To: Design Review Board
From: Tony Leavitt, Senior Planner
Date: June 25, 2018
File No.: DRV18-00312
Subject: CONTINENTAL DIVIDE MIXED USE PROJECT
DESIGN RESPONSE CONFERENCE

**CONTINENTAL DIVIDE
MIXED USE
DRV18-00312**

DESIGN RESPONSE CONFERENCE

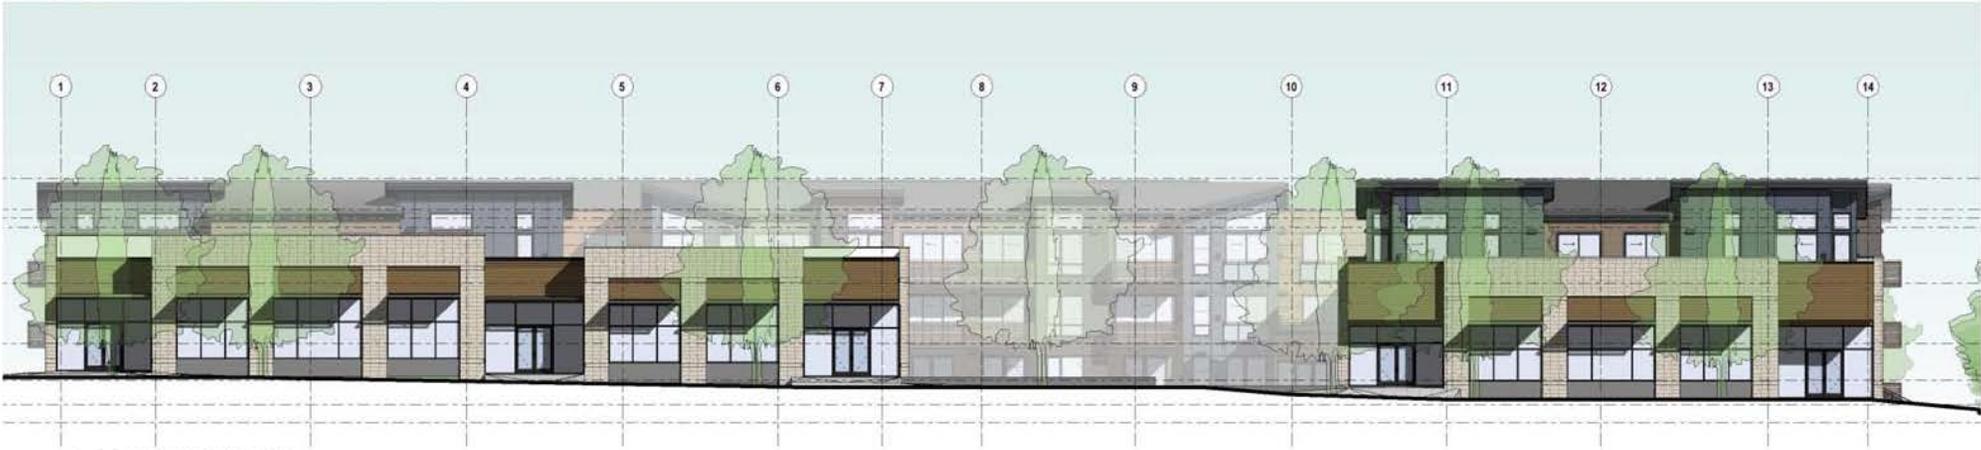
Attachment 2, Sheet 12 contains color elevation drawings and callouts for the proposed building materials. The applicant has been directed to bring larger material samples to the DRB meeting. The DRB should provide feedback to the applicant regarding the proposed materials and colors.
